Improving the tailgate lock

Some customers have informed us that the tailgate lock on their Fruitcat 05/+ machine no longer works properly. We have now looked at this topic and have also been informed 'from the field' that there is a simple solution to the problem. Please proceed as follows:

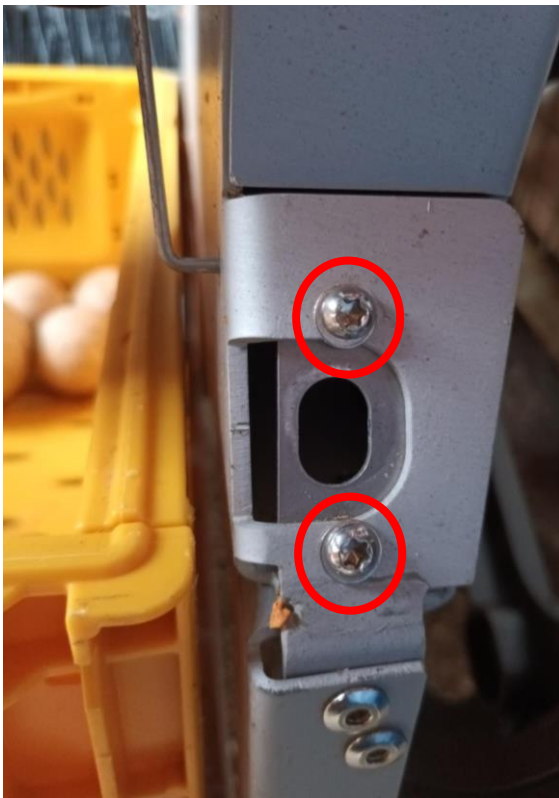
1. Remove the right wheel of your machine.
2. Unscrew the right-hand side cover - it is best to open the 6 Torx screws by hand (these are stainless steel threads that rub easily).
3. Now you can unscrew the counterpart of the lock, the plate with the oval opening. To do this, loosen the two screws marked in red and hold the nut on the back.

4. The panel must now be mounted in the same place, but on the outside of the aluminium frame. Use the same screws, washers and nuts for this. The narrow vertical bar of the plate is on the inside, the wider bar to the right of the oval is on the outside.

5. Now try to close the tailgate several times. The pin of the catch with the spring must be exactly centred in the oval. If this is not the case, you can move the locking plate with its oval cut-out sidewise before fixing it in place.
6. The side cover and the wheel can be refitted. When fitting the side cover, please ensure that the 6 Torx screws do not rub. This can be prevented by applying a drop of oil to the screw and tightening by hand.
